Subject: Possible incorrect mounting of the tow release cable guiding fittings, resulting in malfunction.

Affected gliders: All ASW 19 and ASW 19 B, serial numbers 19001 thru 19405.

84-15 50 618

Fig. 1

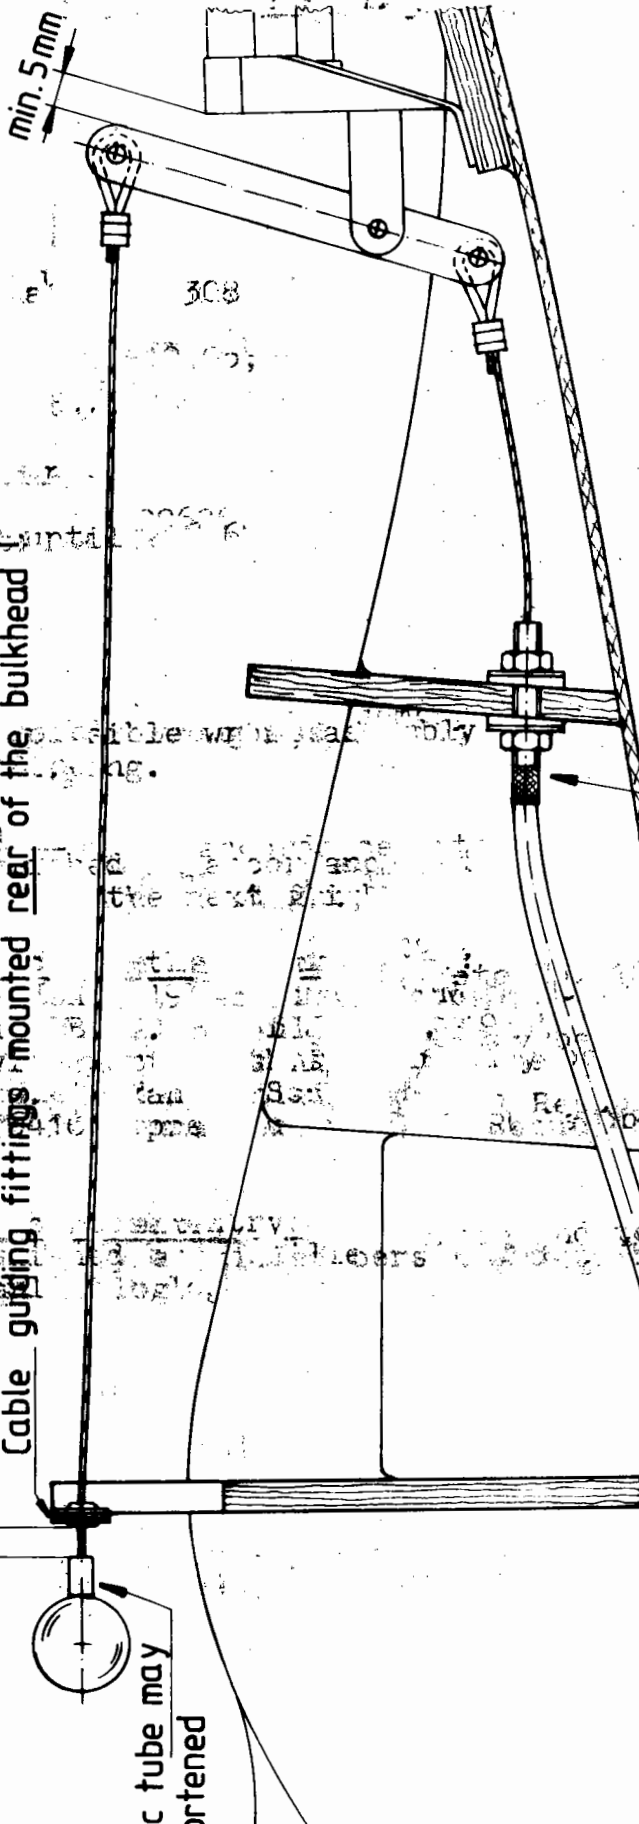
Background: With older ASW 19 and ASW 19 B the cable guiding fittings were mounted in front of the control bulkhead (as shown in Fig.1), while with newer gliders the fittings were mounted as standard rear of the control bulkhead (See Fig.2).

If the cable guiding fittings are mounted in front of the control bulkhead with sufficient neutral travel, the neutral travel disappears in case that the fittings are mounted by mistake rear of the control bulkhead.

Therefore, all ASW 19 and ASW 19 B must be changed as standard to the mounting of the cable guiding fittings to the rear of the control bulkhead, with sufficient neutral travel (Fig.2).

1. Check whether the cable guiding fittings are mounted in front of the bulkhead (Fig.1) or rear of it (Fig.2).
2. If the fittings are mounted in front of the bulkhead, they must be remounted to the rear !
3. Now you have to check whether sufficient neutral travel is left, as indicated in Fig.2. With too little neutral travel the plastic tube at the ball grip may be shortened accordingly and/or the neutral travel may be extended by turning in the turnbuckle (Fig.2).

Here the neutral travel can be extended by turning in the turnbuckle.

Plastic tube may be shortened
